Commonwealth Edison

October 18, 1984

Subject: Byron Generating Station Units 1 and 2
Braidwood Generating Station Units 1 and 2
HVAC Systems
NRC Docket Nos. 50-454/455 and 50-456/457

This letter provides additional information regarding the testing of filters and ducts in the Byron/Braidwood HVAC filter systems. This information is supplied at the request of the NRC Staff to address the questions regarding FSAR commitments.

FIGURE 1
AUXILIARY BUILDING HVAC SYSTEM

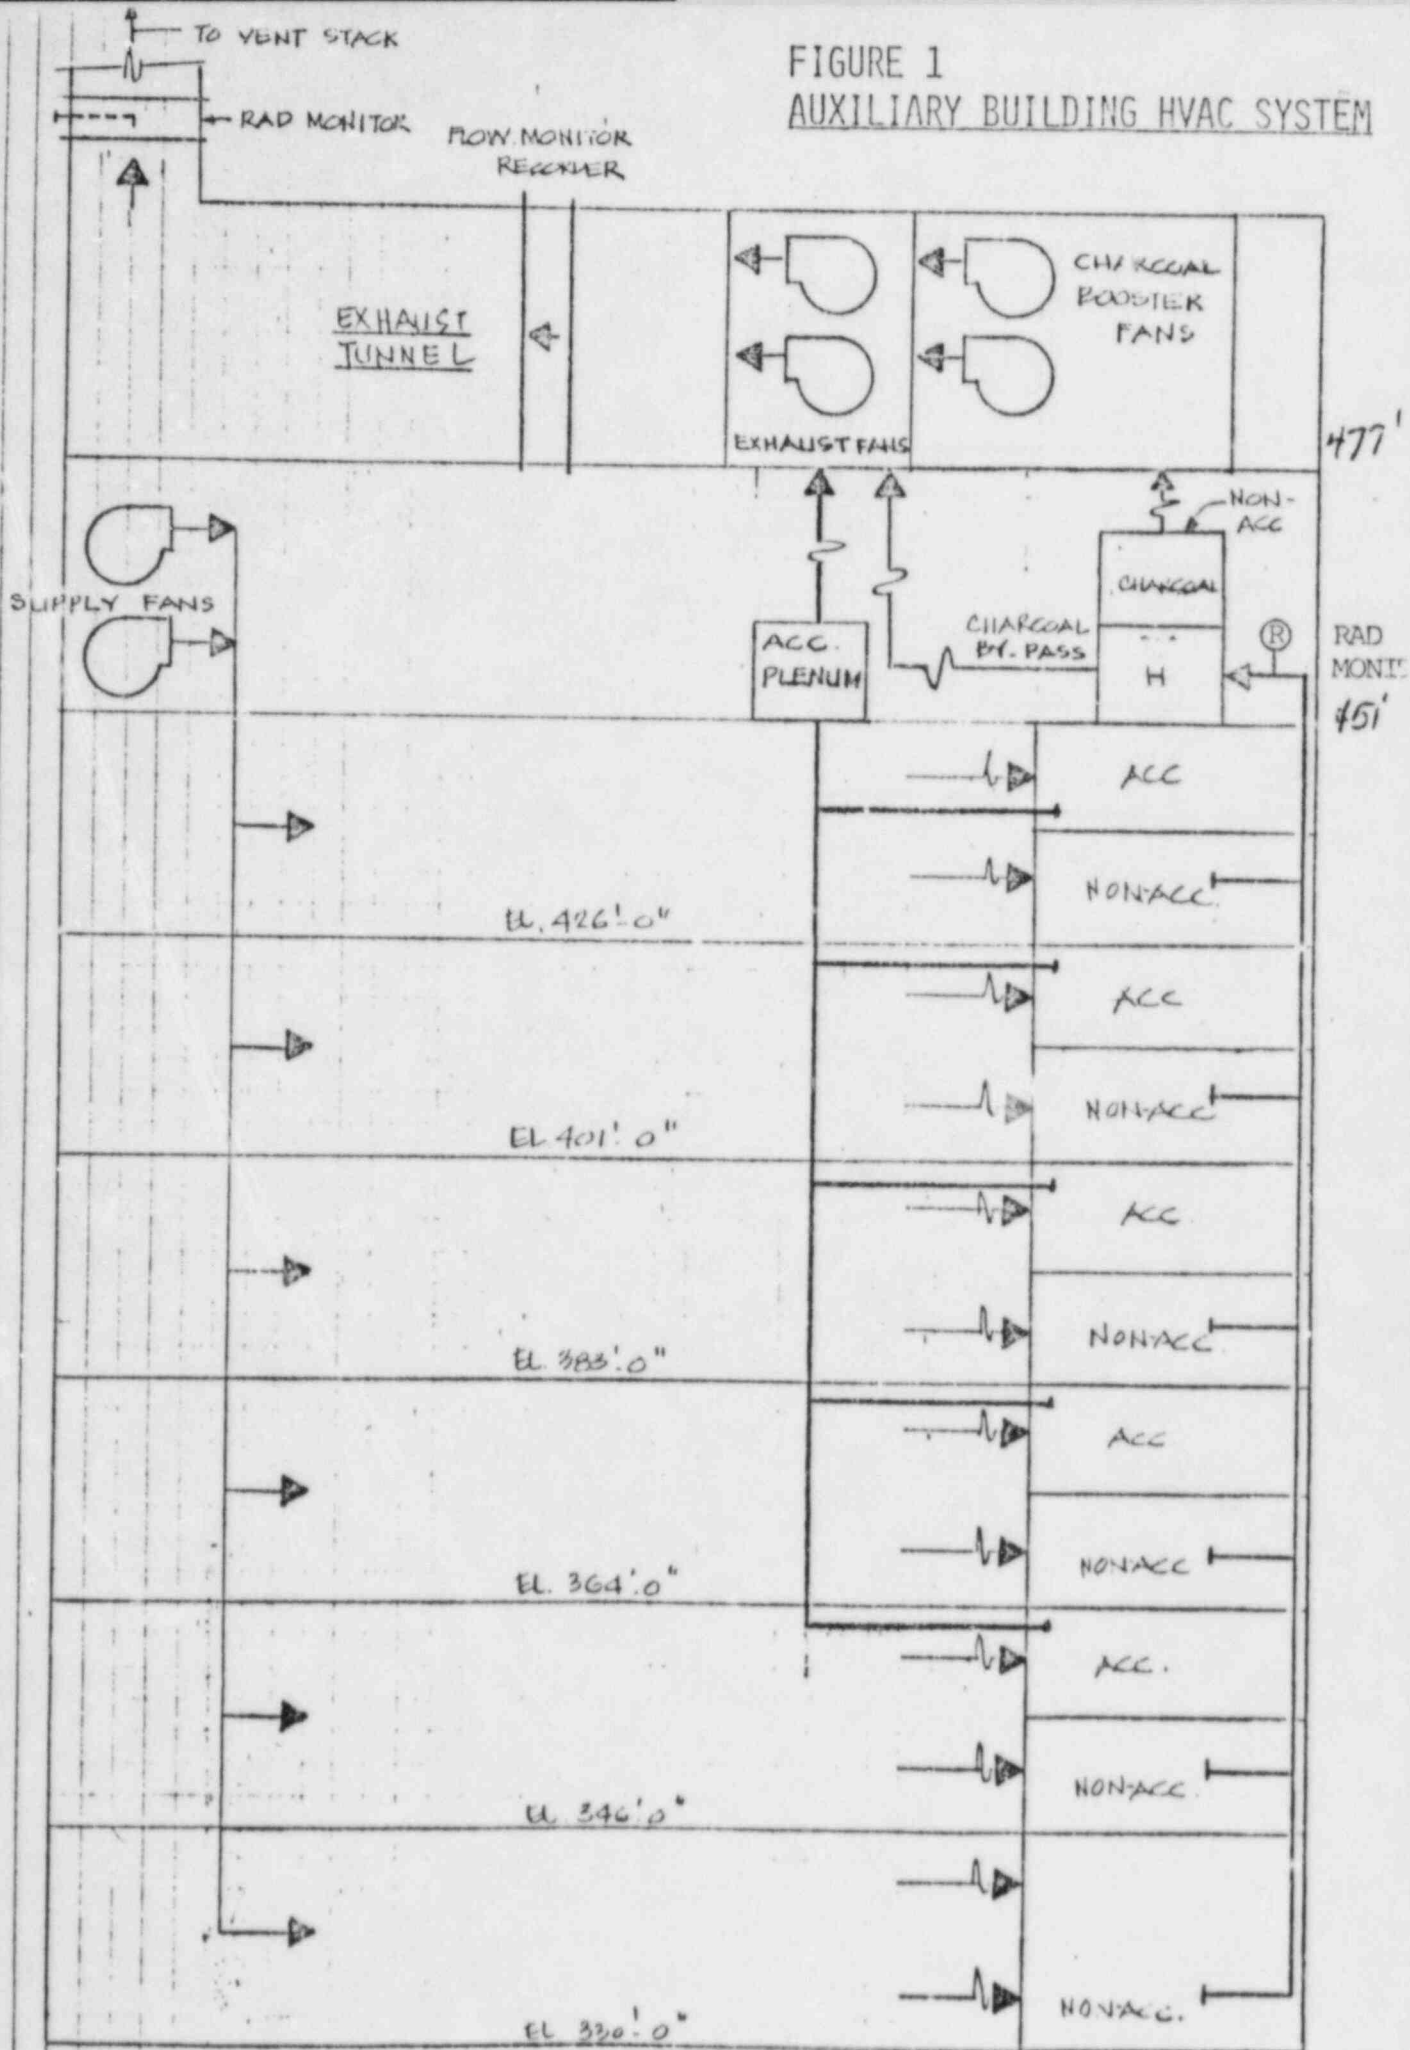
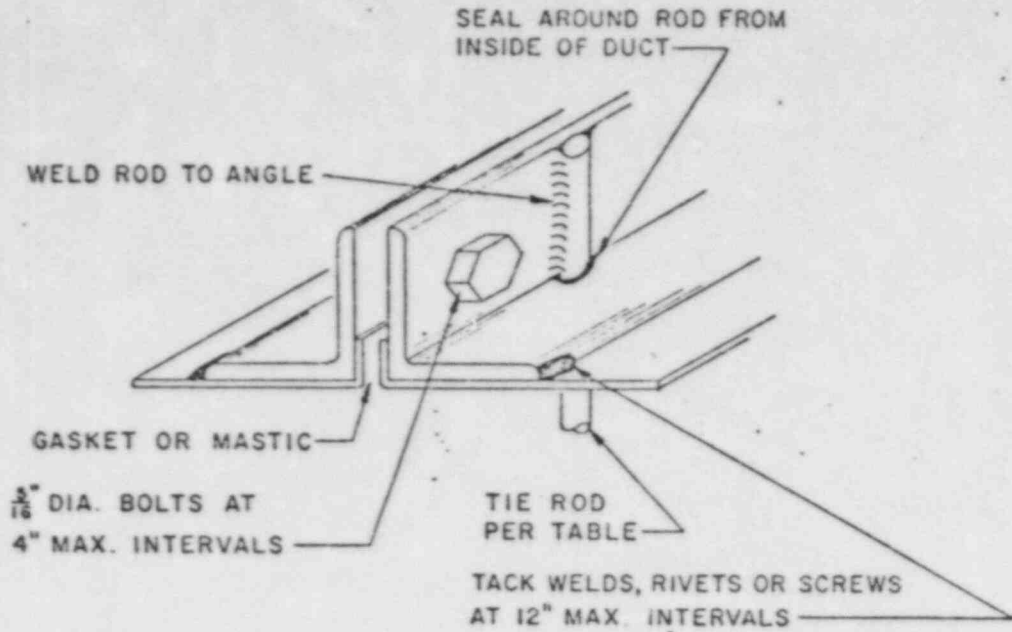
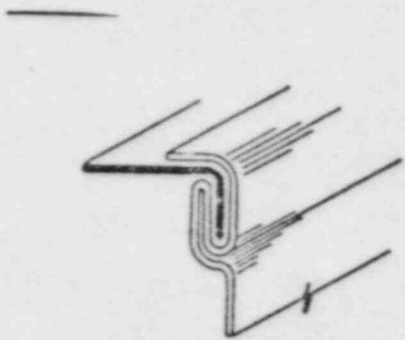
"...THE APPLICANT HAS INDICATED THAT THE DUCTWORK WILL NOT BE LEAK TESTED IN ACCORDANCE WITH ANSI N509-76 AND HAS NOT PROPOSED ANY ALTERNATIVE TESTING FOR THE DUCTWORK; EVEN THE LESS RIGOROUS TESTING OF ANSI/ASME N509-80. THE STAFF INITIALLY ACCEPTED THE APPLICANT'S EXCEPTION TO LEAK TESTING THE DUCTWORK BECAUSE ALL RADIOACTIVITY WOULD LEAK INTO THE DUCTWORK AND WOULD BE FILTERED. HOWEVER, FURTHER CONSIDERATION OF THIS EXCEPTION HAS RAISED OTHER QUESTIONS..."

3.1 "OBVIOUSLY, THE ADDITIONAL IN-LEAKAGE TO THE DUCTS WILL RESULT IN AN INCREASE IN THE QUANTITY OF RADIOACTIVITY RELEASED OFFSITE IN THE EVENT OF AN ACCIDENT."

3.2 "HOWEVER, MORE IMPORTANTLY, A GREATER PROBLEM EXISTS WITH RESPECT TO THE POTENTIAL DEGRADATION OF THE CHARCOAL IN THE ESF FILTER TRAINS DUE TO THE UNKNOWN TRANSMISSION OF FUMES FROM PAINTING, FIRES OR CHEMICAL RELEASES VIA THE LEAKY DUCTWORK. SUCH A TRANSMISSION COULD BE CHRONIC AND PLANT PERSONNEL MAY NEVER LABORATORY-TEST THE CHARCOAL UNTIL THE SCHEDULED REFUELING OUTAGE. IN THE INTERVENING MONTHS, THE PLANT MAY HAVE BEEN OPERATING WITH CHARCOAL INCAPABLE OF PERFORMING AT THE EFFICIENCY ASSUMED IN THE STAFF'S SER.

3.3 "...THE STAFF IS ALSO CONCERNED THAT THE RELATIVE HUMIDITY SEEN BY THE CHARCOAL ADSORBERS MAY BE ALTERED DUE TO THE VARIATION IN THE FLOW RATE BROUGHT ABOUT BY THIS DUCTWORK IN-LEAKAGE FROM THE VARIOUS SOURCES TO THE FILTRATION UNITS AND THAT THE ANALYSES PRESENTED BY THE APPLICANT JUSTIFYING THE EXCLUSION OF ELECTRICAL HEATERS MAY BE INVALIDATED."

"THEREFORE, IT IS THE STAFF'S POSITION THAT THE DUCTWORK ASSOCIATED WITH THE ESF FILTER SYSTEMS MUST BE PRESSURIZED AND ALL AUDIBLE LEAKS MUST BE LOCATED AND SEALED. FURTHERMORE, IN ACCORDANCE WITH ANSI/ASME N509-80, ALL DUCTS MUST BE SUBJECTED TO A QUANTITATIVE MEASUREMENT OF LEAKAGE UNLESS THE DUCT IS LOCATED WITHIN A CONTAMINATED SPACE OR PROTECTED SPACE (AS DEFINED IN ANSI/ASME N509-80) OR HAS A LENGTH OF THIRTY FEET OR LESS MEASURED EITHER FROM THE FAN OR THE AIR CLEANING UNIT TO ITS TERMINUS. THE ALLOWABLE LEAK RATES FOR THE DUCTS SHOULD BE IN CONFORMANCE WITH SECTION 4.12 OF ANSI N509-80."

FIGURE 1 IS A SIMPLIFIED SCHEMATIC WHICH SHOWS ONE-HALF OF THE AUXILIARY BUILDING SYSTEM, WHICH IS SHARED BETWEEN UNIT 1 AND UNIT 2.

THE AUXILIARY BUILDING HVAC SYSTEM SERVES MULTIPLE FUNCTIONS. IT OPERATES DURING NORMAL PLANT OPERATION TO PROVIDE CONDITIONED AIR TO THE GENERAL AREAS FOR COOLING PURPOSES. THE AIR SUPPLIED TO THE GENERAL AREA IS THEN INDUCED INTO CUBICLES WHICH HAVE BEEN CATEGORIZED AS "ACCESSIBLE" AND "NON-ACCESSIBLE." THE "NON-ACCESSIBLE" CUBICLES, SHOWN ON THE ATTACHED, ARE SO CATEGORIZED DUE TO THEIR POTENTIAL FOR BECOMING CONTAMINATED DURING EITHER NORMAL OPERATION OR POST-ACCIDENT. AS YOU CAN SEE IN THIS LISTING OF NON-ACCESSIBLE CUBICLES, SEVERAL CUBICLES OTHER THAN THE ESF PUMP CUBICLES ARE CATEGORIZED AS "NON-ACCESSIBLE." ALSO, "NON-ACCESSIBLE" CUBICLES OR AREAS ARE FOUND ON EVERY ELEVATION OF THE AUXILIARY BUILDING.

THE AIR IS INDUCED INTO THE CUBICLES BY THE AUXILIARY BUILDING EXHAUST SYSTEM, WHICH DRAWS AIR FROM EACH CUBICLE, THROUGH PREFILTERS AND HEPA'S AND DISCHARGES THAT AIR TO THE OUTDOORS THROUGH THE PLANT VENTILATION STACK.

THE AIR DRAWN FROM THE "NON-ACCESSIBLE" CUBICLES IS MONITORED BY RADIATION MONITORS LOCATED IN THE DUCTS, UPSTREAM OF THE FILTER UNITS, AS WELL AS IN THE PLANT VENT STACKS. ON A HIGH RADIATION SIGNAL, THE CONTROL ROOM OPERATOR CAN DIRECT THE "NON-ACCESSIBLE" AREA EXHAUST THROUGH CHARCOAL AND HEPA FILTERS. NORMALLY,

HOWEVER, THESE FILTERS ARE BYPASSED AND NO EXHAUST AIR FLOWS THROUGH THESE FILTERS.

THE EXHAUST DUCTS FROM THE "ACCESSIBLE" AREAS IS ROUTED FROM THESE AREAS THROUGH THE GENERAL AREA TO THE PRE/HEPA FILTERS. ACCESSIBLE AREA EXHAUST DUCTWORK, EXCEPT FOR ABOUT A 5 FOOT SECTION OF DUCT, IS NOT ROUTED THROUGH NON-ACCESSIBLE AREAS.

ALL DUCTWORK ON THE SUCTION SIDE OF THE EXHAUST FANS, WHICH IS THE MAJORITY OF DUCTWORK, IS UNDER A NEGATIVE PRESSURE. THERE IS NO DUCTWORK BETWEEN THE PRE/HEPA FILTER PLENUMS AND THE MAIN EXHAUST FANS AND ONLY A SHORT DUCT (LESS THAN 30 FEET) BETWEEN THE CHARCOAL FILTER BOOSTER FANS AND THE MAIN EXHAUST FAN. THIS DUCTWORK IS WITHIN A HOUSING.

FIGURE 4

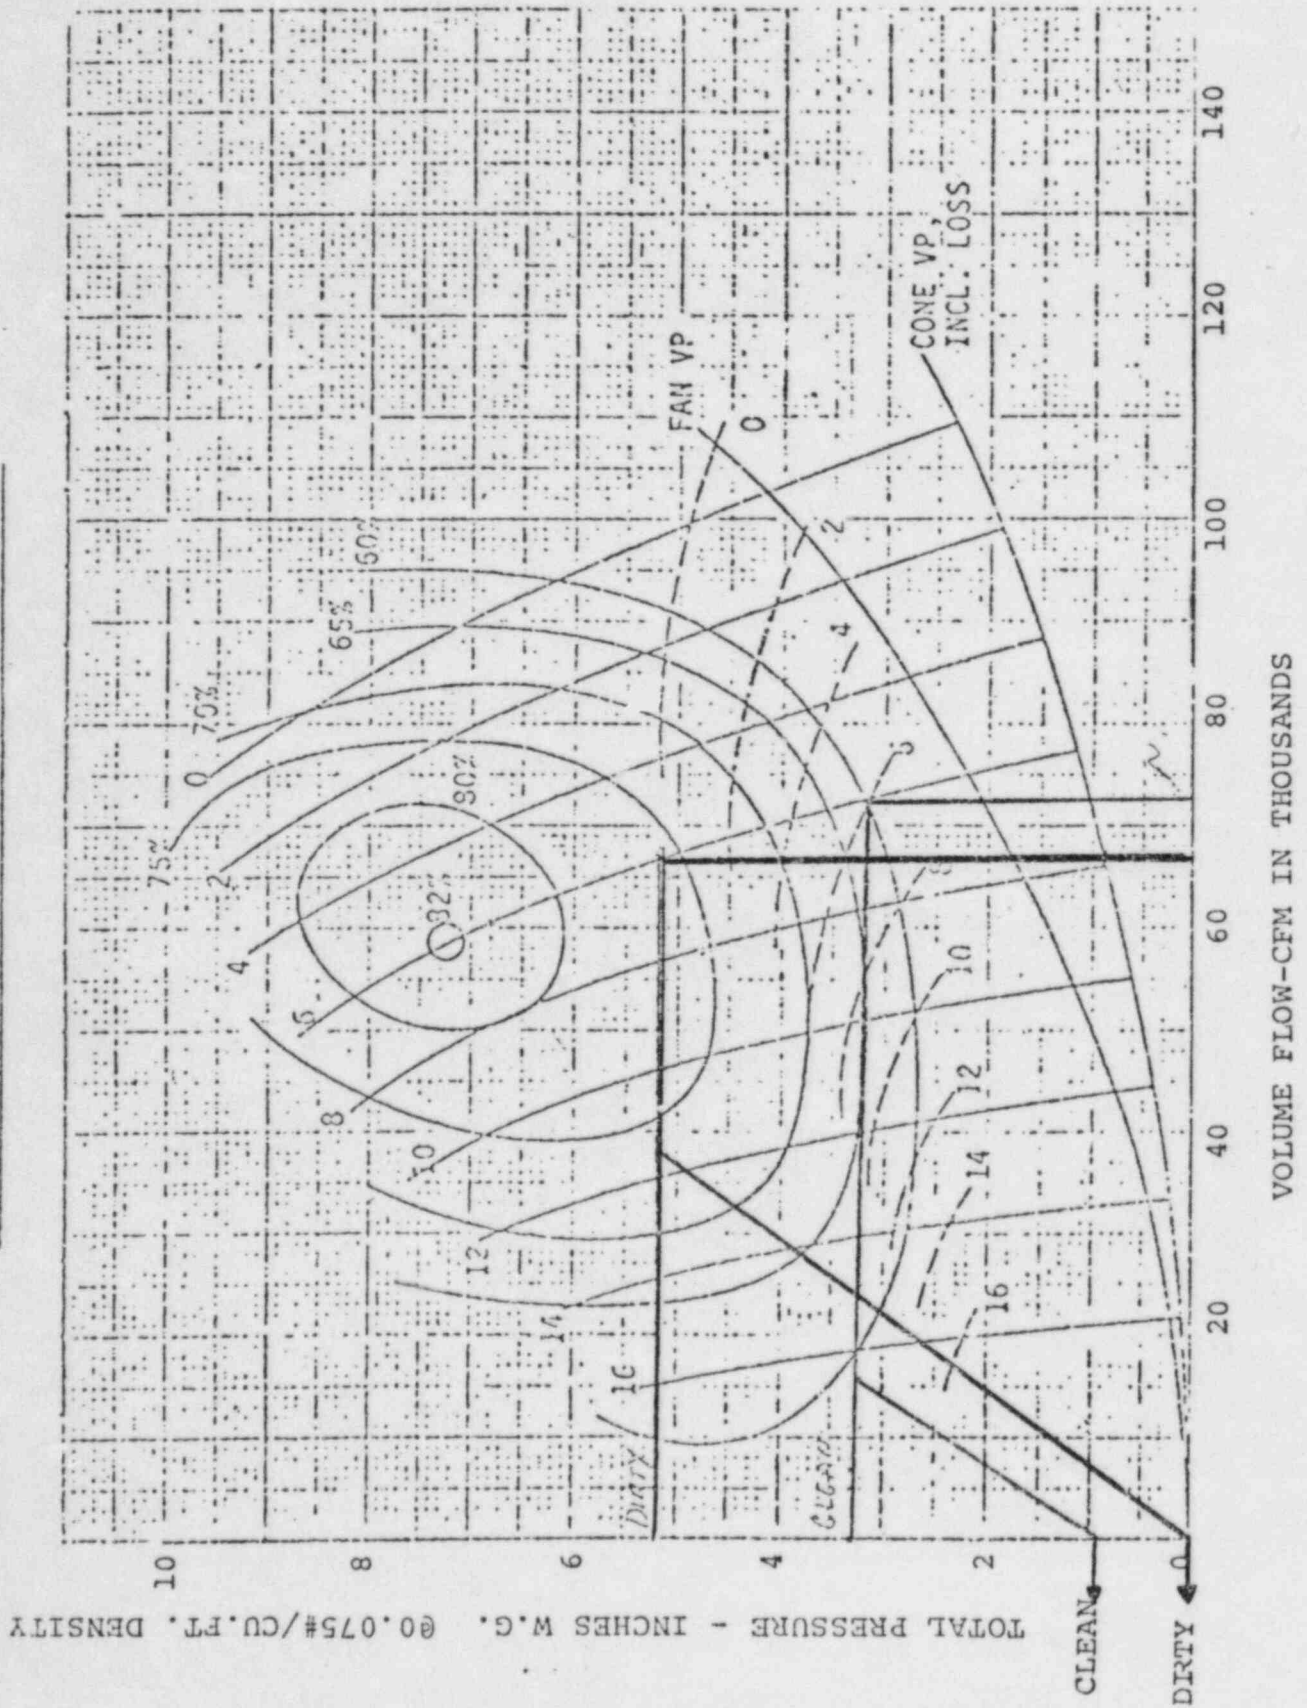
"...IT IS NOT APPARENT TO THE STAFF HOW THE APPLICANT WILL BE ABLE TO ENSURE THAT THE FLOW RATE IN THE NON-ACCESSIBLE AREA EXHAUST FILTER SYSTEMS AND THE CONTROL ROOM EMERGENCY MAKE-UP AIR FILTERS IS MAINTAINED WITHIN +10% OF ITS DESIGN FLOW WHEN FLOW IS ONLY SENSED. IT MUST BE ENSURED THAT THE RESIDENCE TIME IN THE CHARCOAL ADSORBER IS MAINTAINED AT THE DESIGN VALUE OF 0.25 SECONDS PER TWO INCHES OF CHARCOAL AND THAT THE FLOW RATE CAPABILITY OF THE HEPA FILTERS IS NOT EXCEEDED. THEREFORE, THE APPLICANT SHOULD ADDRESS HOW FLOW WILL BE MAINTAINED TO SATISFY THESE CONDITIONS..."; "...THE APPLICANT SHOULD ALSO ADDRESS THE RECORDING OF FLOW FOR THE FUEL HANDLING BUILDING FILTRATION UNITS."

FIGURES 4 AND 5 PROVIDE THE FAN NORMAL OPERATING POINTS BETWEEN THE CLEAN AND DIRTY FILTER RESISTANCE IN THE SYSTEM FOR NON-ACCESSIBLE FILTERS AND FUEL HANDLING BUILDING EXHAUST FILTERS, RESPECTIVELY. AS CAN BE SEEN FROM THESE CURVES, FOR SYSTEM NORMAL OPERATING CONDITIONS, THE FLOW VARIATION BETWEEN TWO POINTS IS LESS THAN 10%, THUS ASSURING DESIGN FLOW.

FOR ANY POSTULATED SYSTEM UPSET CONDITIONS, THE FAN WILL BE OPERATING BEYOND THE TWO OPERATING POINTS, WHICH WILL THEN BE ALARMED AT MCP BY EITHER THE HIGH OR LOW ΔP ALARM OF THE FAN THUS ALERTING THE OPERATOR FOR FURTHER ACTION.
